## Design Review Subcommittee (DRSC)

Meeting Date: December 13, 2017

**SUBJECT:** **Minor Cultural Heritage Permit (MCHP) 17-300, 102 Ave Victoria Façade Improvements**, a request to consider façade improvements to a multi-tenant, single-story commercial building at 102 Avenida Victoria.

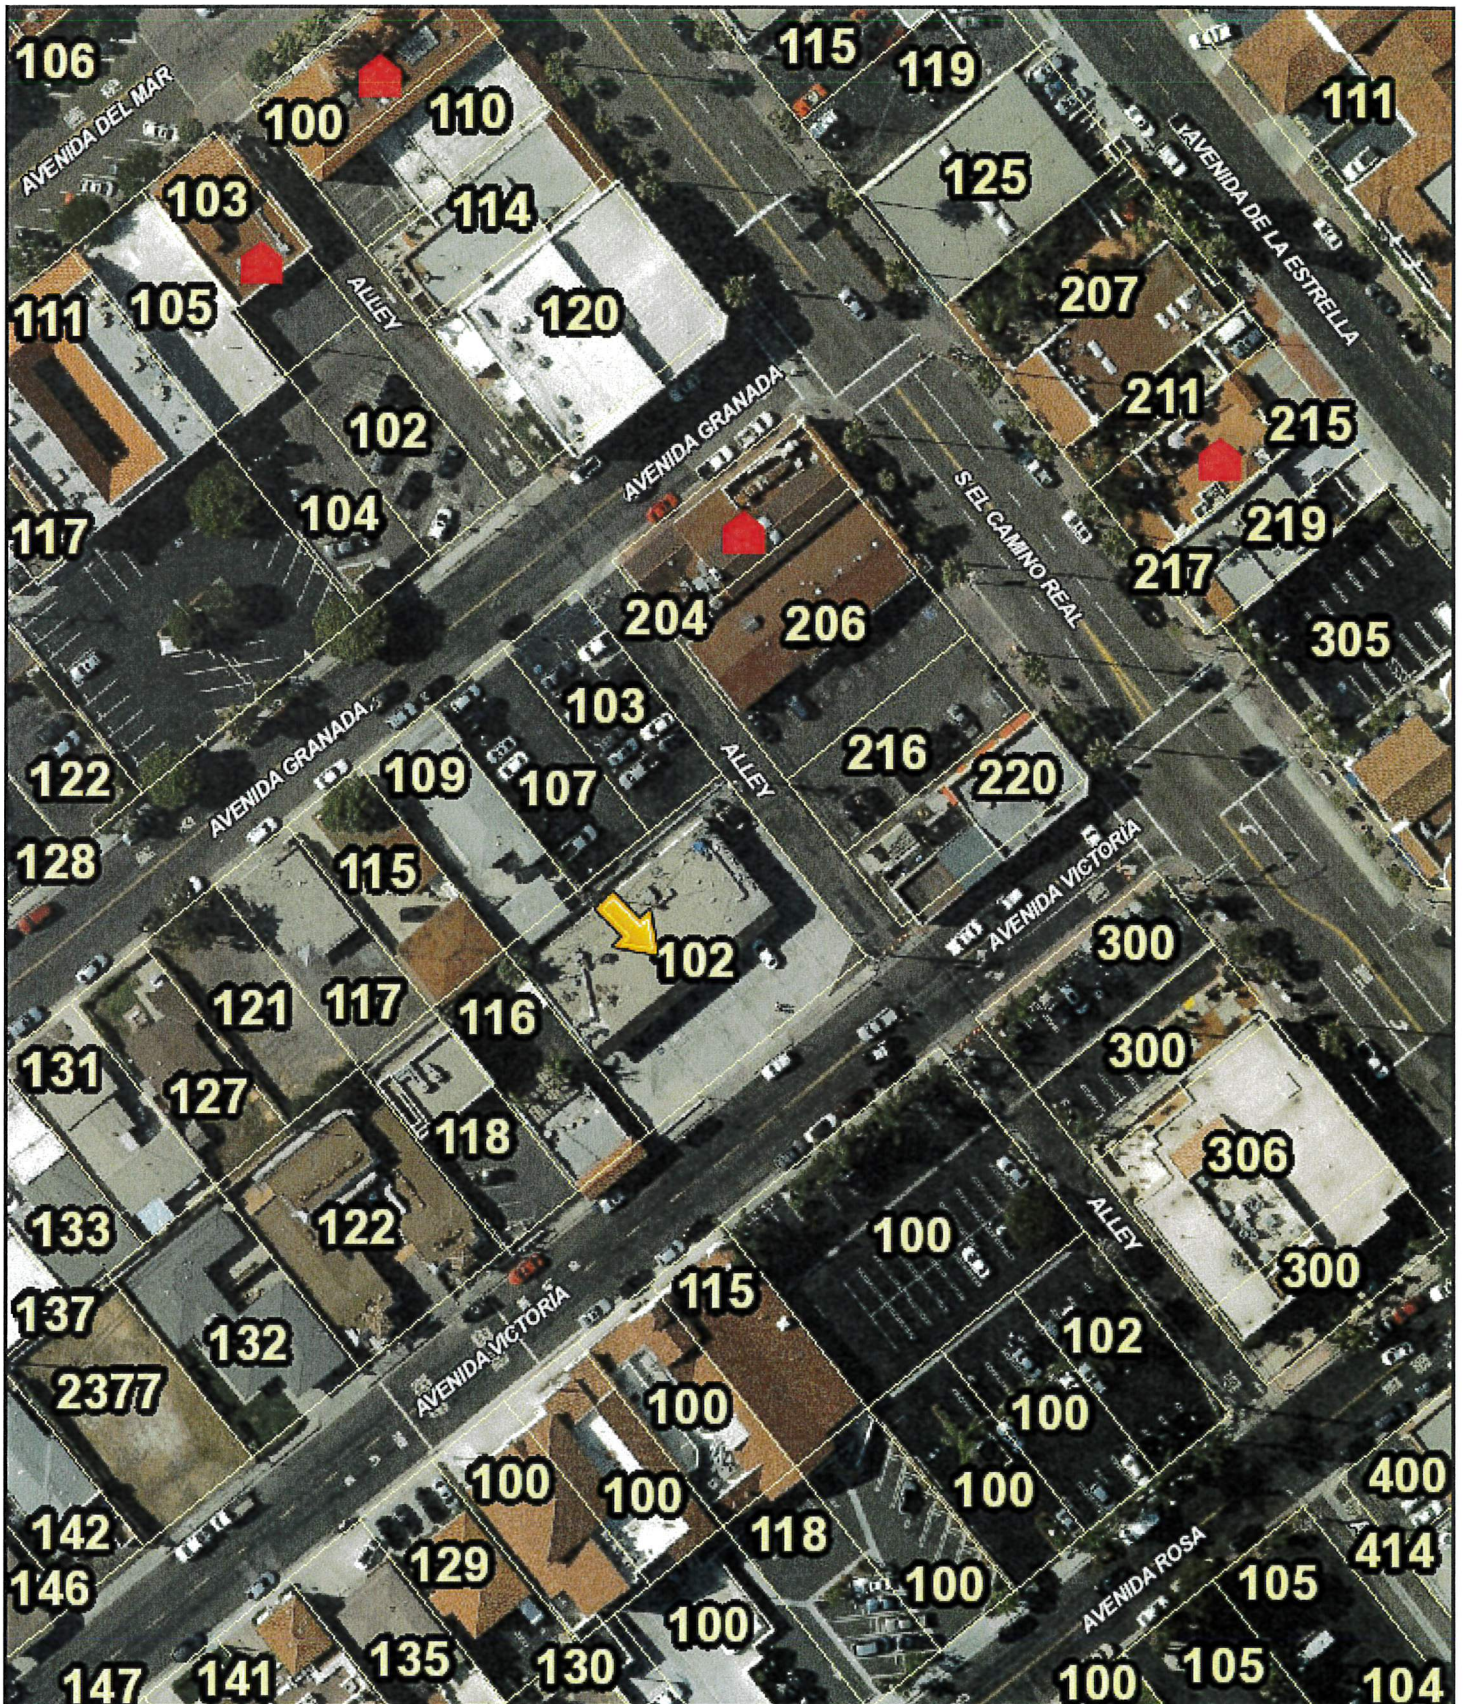
Recommendation	Sample Image
<p>1. Apply a smooth white plaster finish to both the front and alley side elevations for material consistency from the public ROW and remove the control joints.</p>	 <p style="text-align: right; font-size: small;">NORTHEAST CORNER VIEW</p>
<p>2. Add additional wall/plaster massing to “support” the building around the two existing posts that are offset of the central part of the front elevation. Consider adding additional massing to the tower elements by incorporating archways instead of square openings.</p>	
<p>3. Steel doors and aluminum windows are acceptable provided their finish and detailing is consistent with a wood door/window. They should have traditional recessed profiles (standard is 8” for windows and 12” for doors), and the</p>
